Changing the gain resistor in the 2102 Breakdown / Hipot Adapter

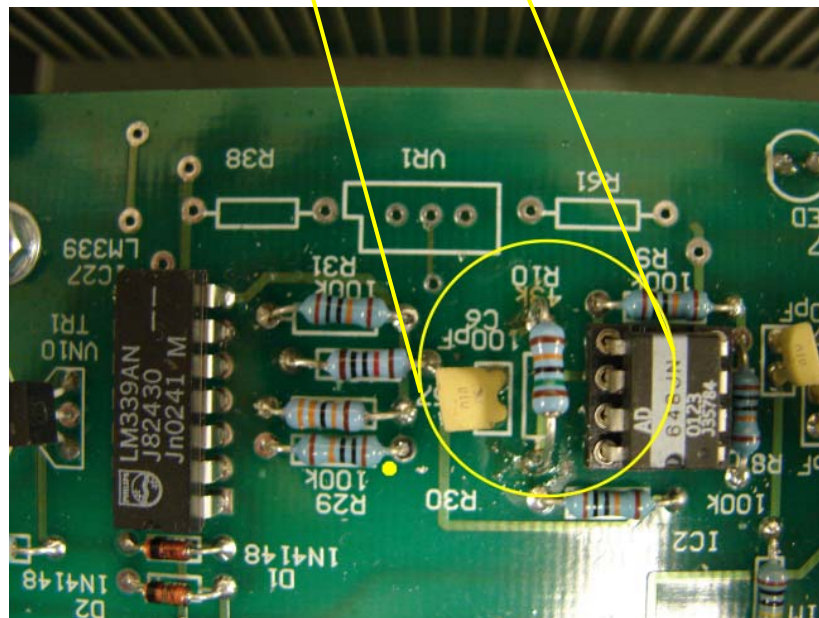
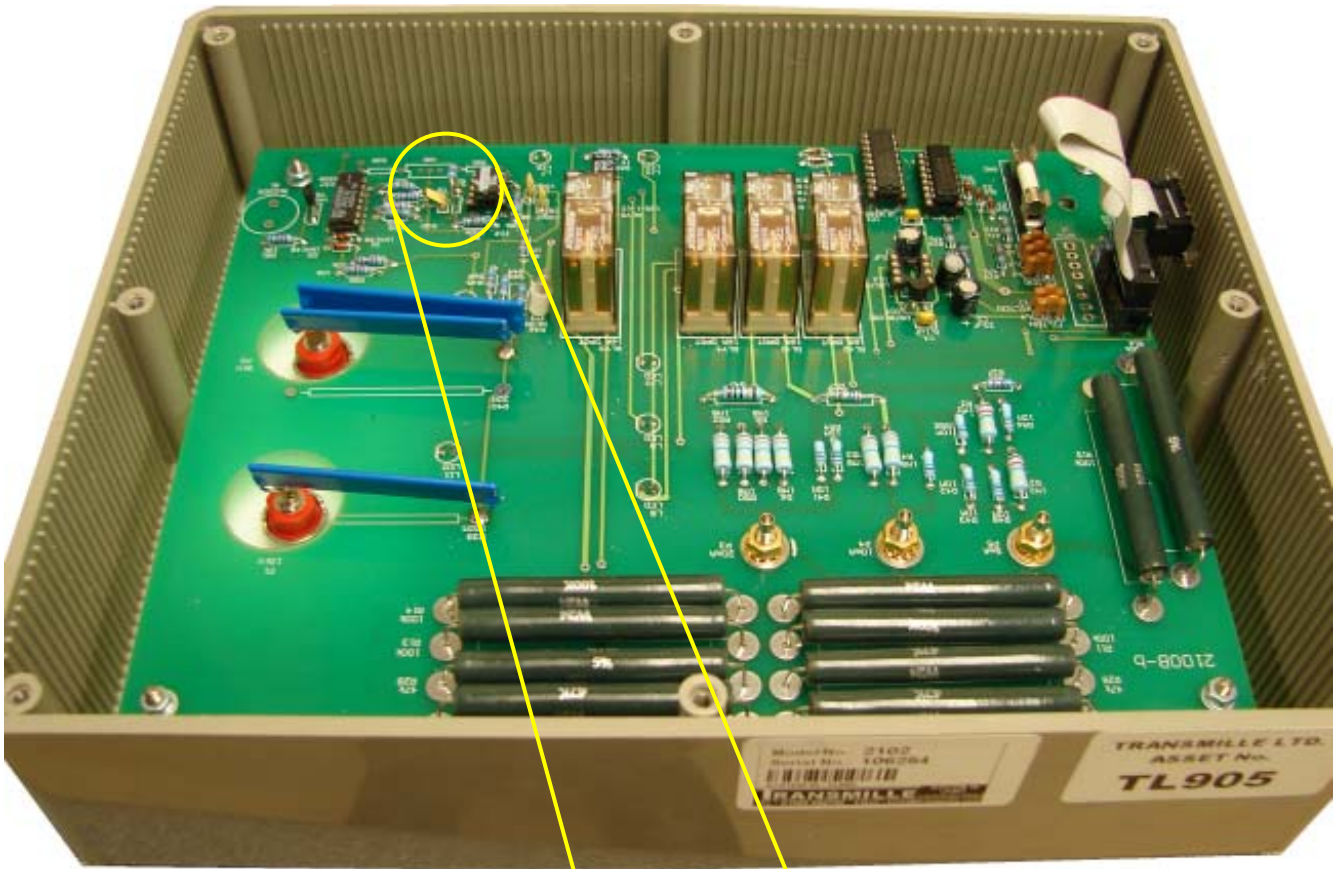
To modify the gain of the 2102 adapter, the following resistor should be changed :

To modify the gain, replace resistor **R10** with a **150kΩ** resistor
